Subject:
 Draft permit, 785854:Kschwall

RE: Comments on the Proposed Permit for OCMC 785854:Kschwall

RE: <u>Protecting Near Shore Marine Environment</u> 785854:Kschwall

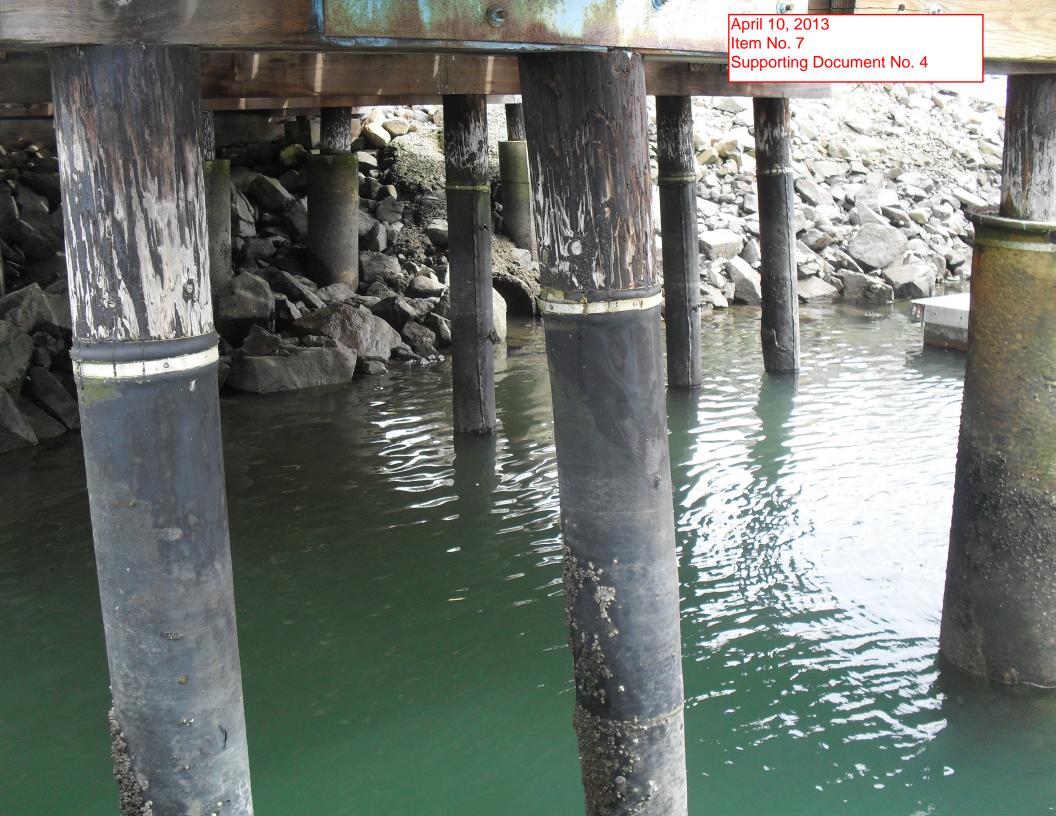
The attached pictures taken at 2:10 pm low tide along the N & S outfalls. The high tide is near the bottom of vigitation and parnacle line shown on the rubber sleeves. Both the N & S outfalls location are structured as vertical steel curtain supported by rocks rip-raps. Sampling sediment in the sub-tidal zone of Part 1 is not applicable to Oceanside special setting cited above. Please cosndier the attaments as part of Oceanside recent comment letter on the proposed permit.

I respect our differences in interpreting the intent and letter of the regulations as stated in California Part 1. There is no "**Subtidal Zone'' at Oceanside Harbor to be sampled**. The Harber perimeter consists of vetical steel curtain rip-rapped by large rocks as shown in the previpusly sent picturs and as previously mentioned.
